ADDENDUM NO. 4

PROJECT: Washtenaw ISD – High Point School
DESCRIPTION: Architectural and MEP
BID PACKAGE RELEASE NUMBER: 003
CLARK/AXIOM PROJECT NO: 2832/1004

PROJECT: Washtenaw ISD – High Point School

E3.1J-BP3

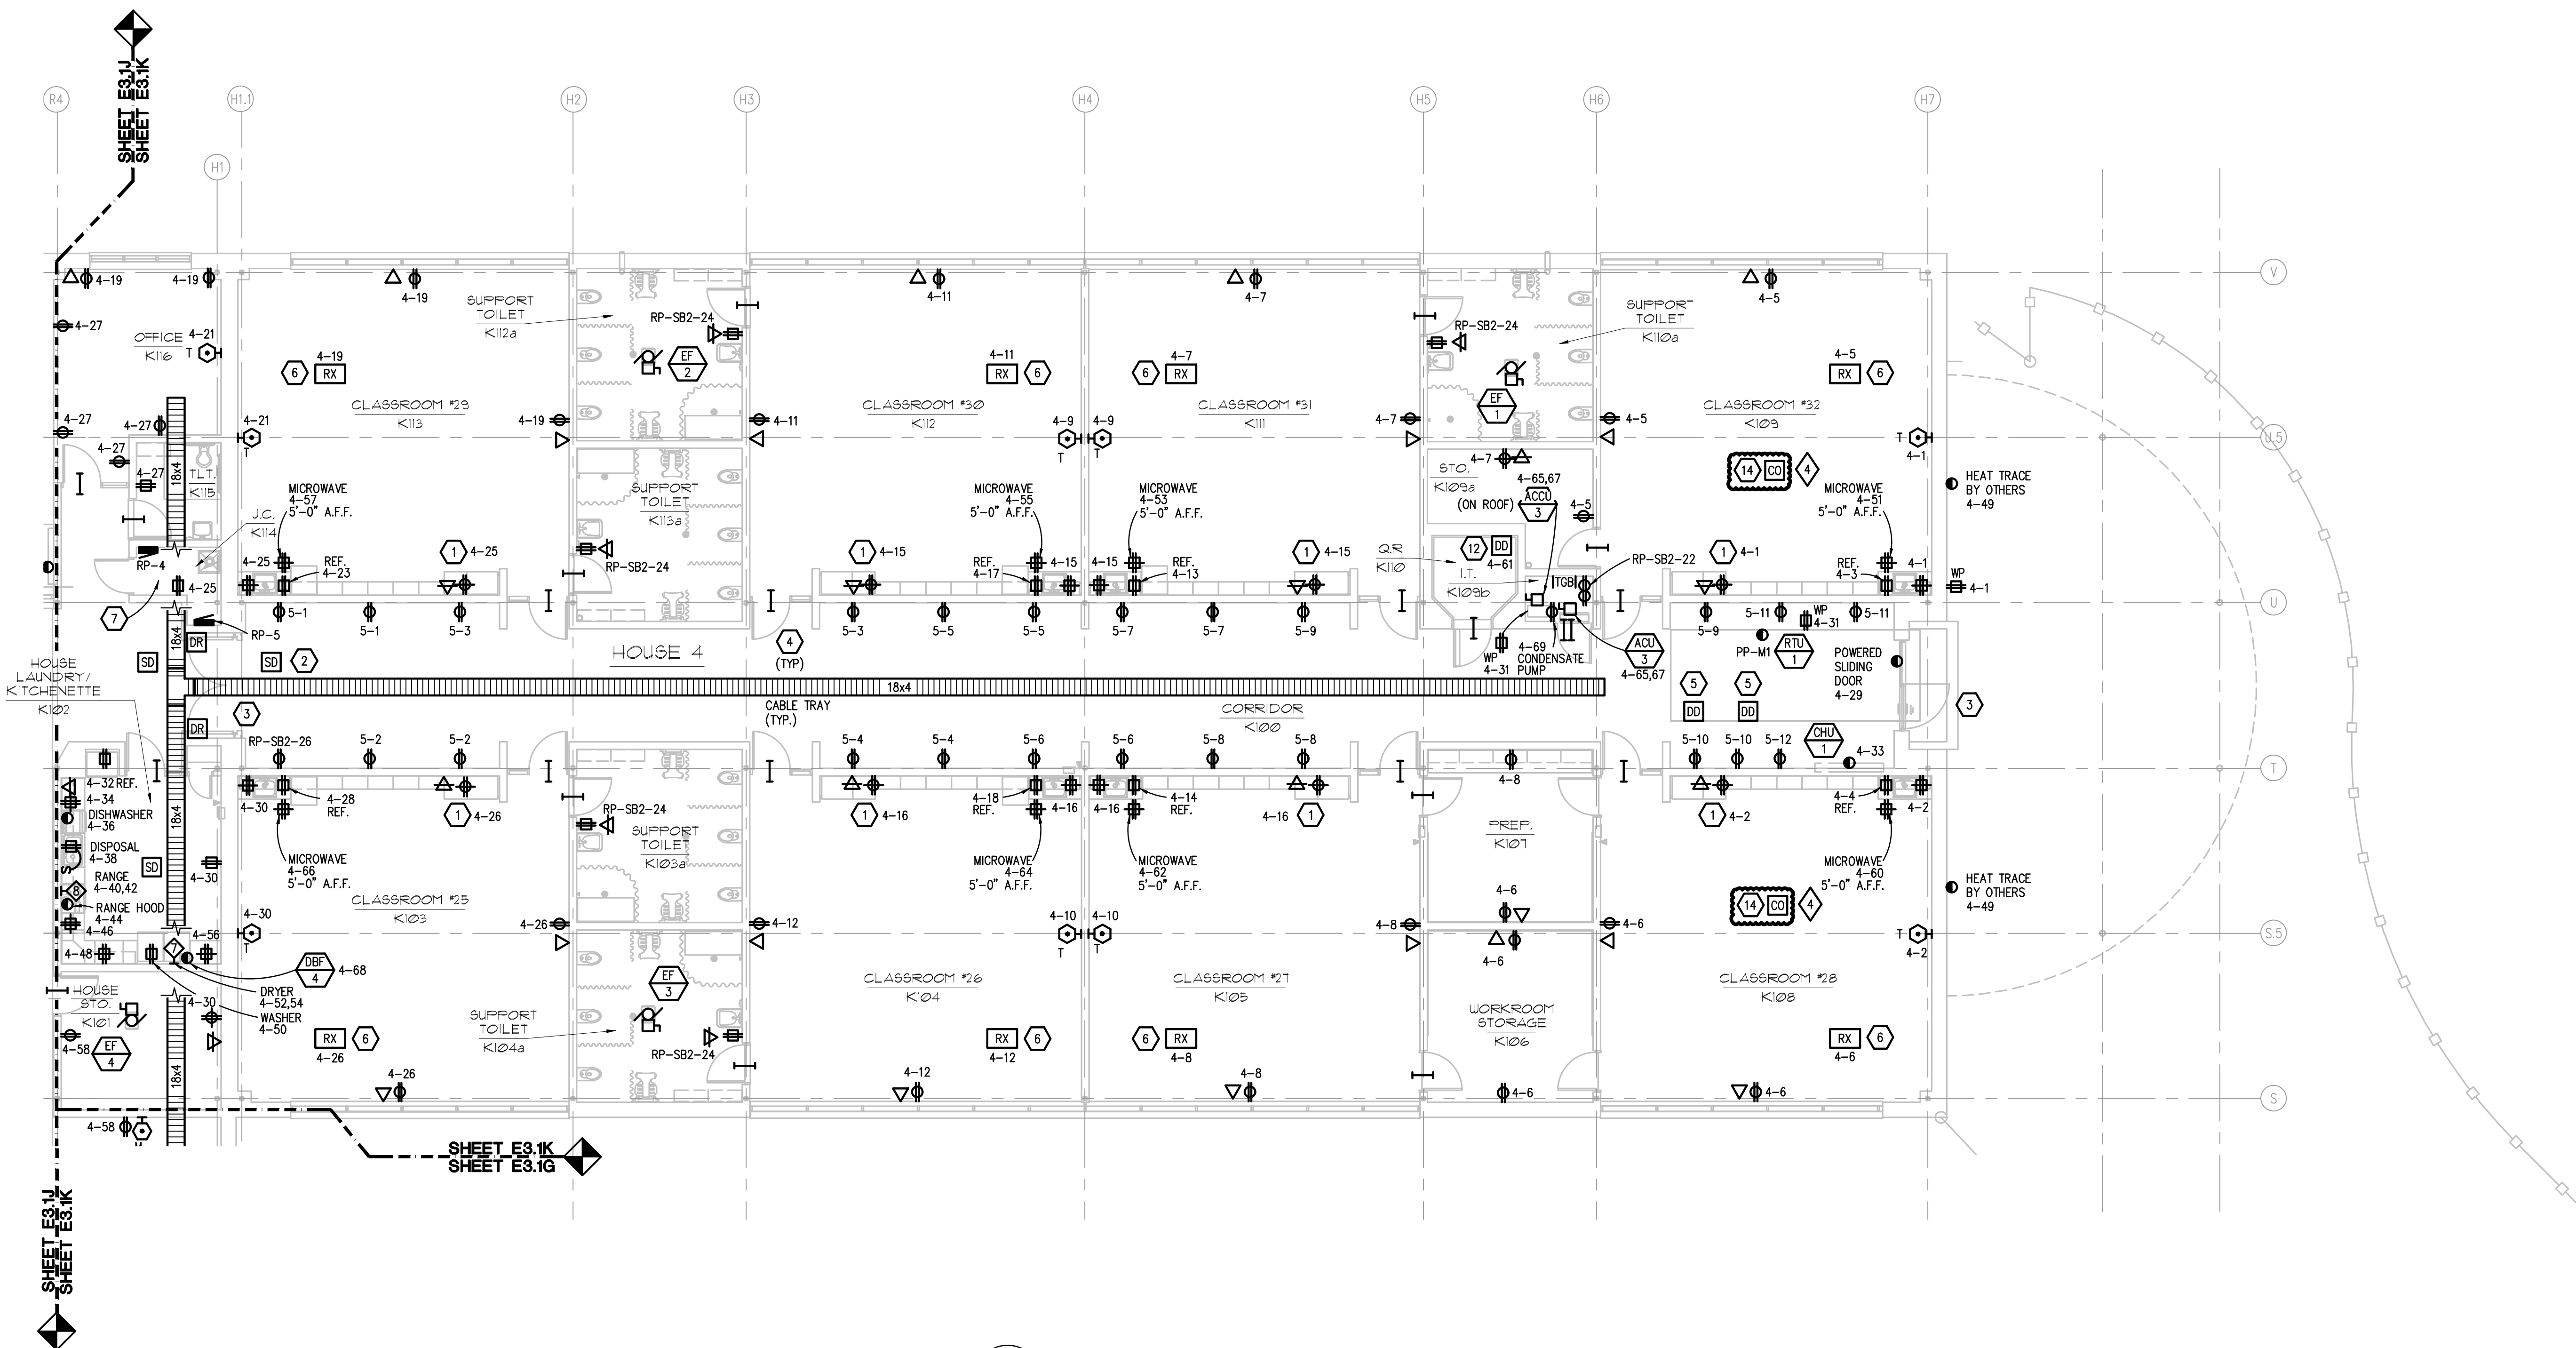
- ED-9 Refer to Drawing No. E3.1J-BP3 (reissued):
- A. Added Carbon Monoxide Detector as indicated.
 - B. Added Construction Note No. 14 and 15 as indicated.
